REFERENCE:	Nova Bus Manuals
SECTION:	02: Battery Door
RS N°:	MQR 7621-2744
EFFECTIVE IN PROD.:	NA

SUBJECT:	Battery door slam latch
JUSTIFICATION:	Due to a shortage, N620000263 was installed as an alternative to temporarily replace N81288.

Figure 3 - Remove N620000263

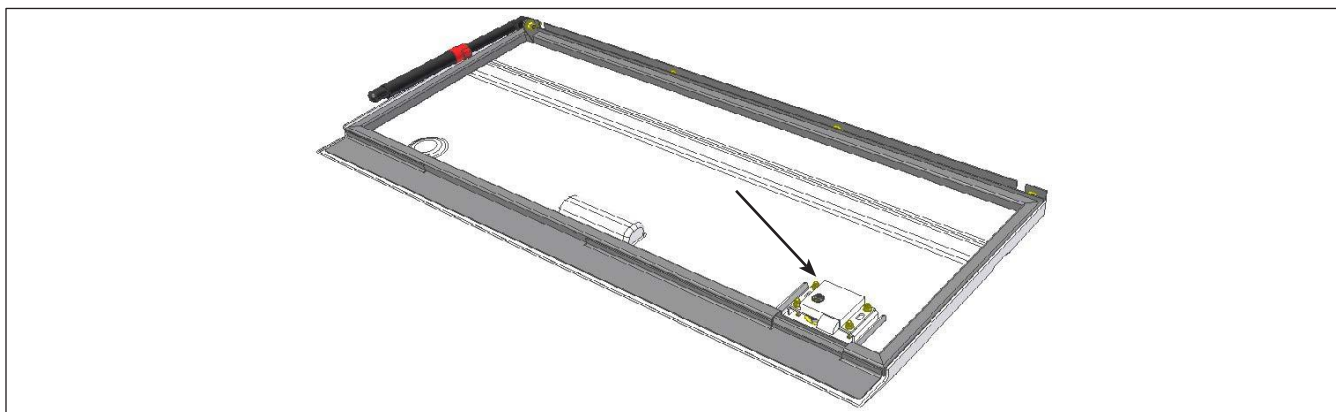
- 2.1. Remove N620000263 and replace by N81288. See next figures. Retain hardware.

Figure 4 - Remove Bolt for the Turn Key

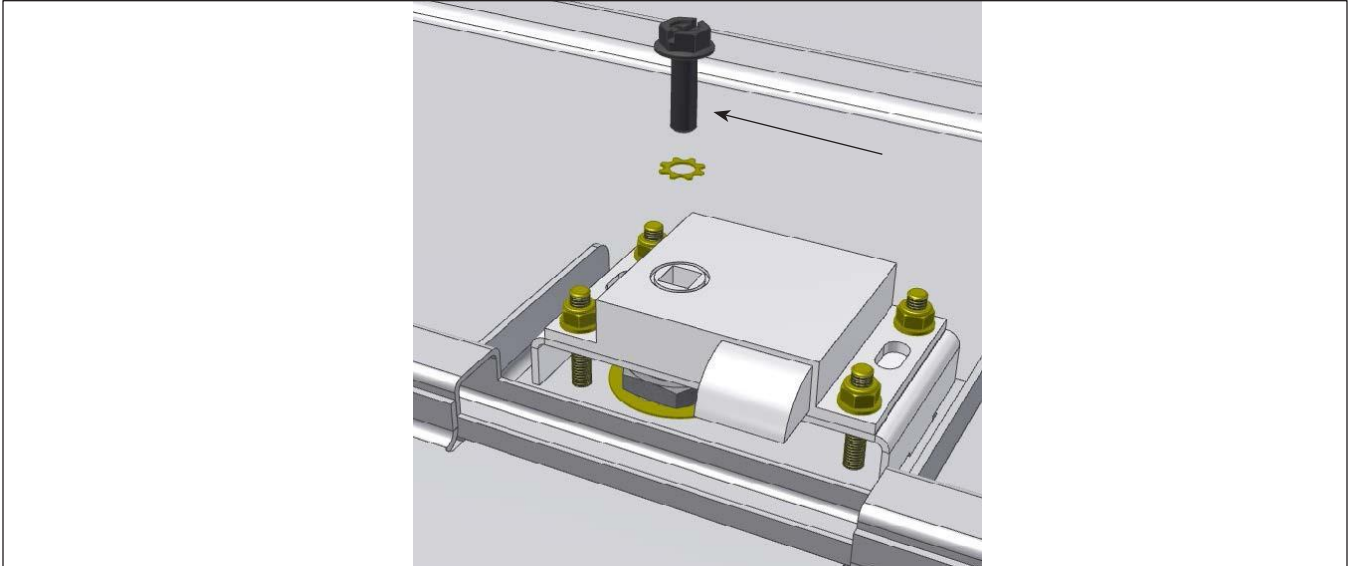
- 2.2. Installation is the opposite of removal. Torque the retained bolt shown in figure 4 to  $2.95 \pm 0.4$  lb-ft ( $4 \pm 0.5$  N·m). Apply a torque seal.
- 2.3. The vehicle can return to service.
